Draft Variation 307 should be refused because:

- **Block 15 is unsuitable for re-zoning as RZ4. To proceed with this Variation would be contrary to the Draft ACT Planning Strategy; it does not provide more choice in housing types.**
- **A better option would be to zone the Block RZ1 or RZ2, with the lower flood prone areas remaining as Open Space.**
 - **This would encourage younger families to move into the area.**
 - **Retain the neighbourhood character and the green corridor from Manuka to Mugga Way.**
 - **Supply much needed housing stock to replace those homes bulldozed to make way for apartments.**
 - **Reduce the pressure on traffic, parking other infrastructure issues.**
- **It is not in the community interest for the Brumbies to benefit from windfall profits by cashing in a Concessional Lease.**

Fig. 1. Population in Inner South Canberra from 1991-2010. RH column shows total population on Inner South; left hand column shows populations in the nine Inner South Suburbs.

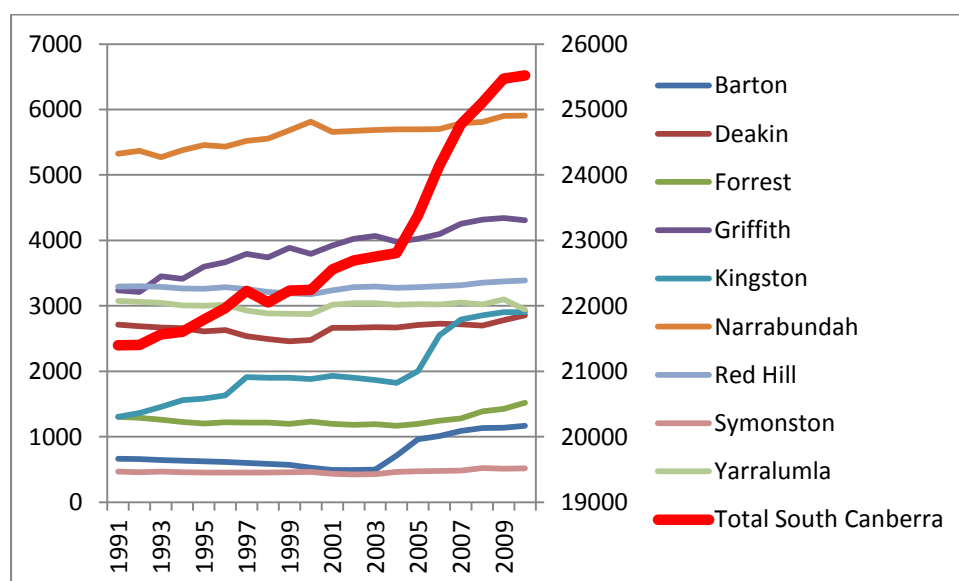
The plot below provides a chart showing the population increase from 1991 to 2010 from the ABS statistics available on its website. I am not sure that data before that time are very relevant in any case.

What graphs show are that the population in the Inner South has gradually increased during this period and particularly from 2004. The slight fall from 2009 is may be a due to several factors which there is not time and space to discuss here. The main point is that suburbs show a slight increase over the same period. Griffith's population will increase significantly over the next few years with the completion of several sets of apartments and the opening of the Residential Old-Age care facility near the Griffith shops. What needs to be addressed is the population profile, and in the time frame to prepare this submission I have not been able to research this. The point is that ACTPLA's assertion that it supported the proposal because "*The proposal will further assist in offsetting population decline in South Canberra*" is not supported by the evidence. There is no decline in population!

ESD's response is seriously flawed.
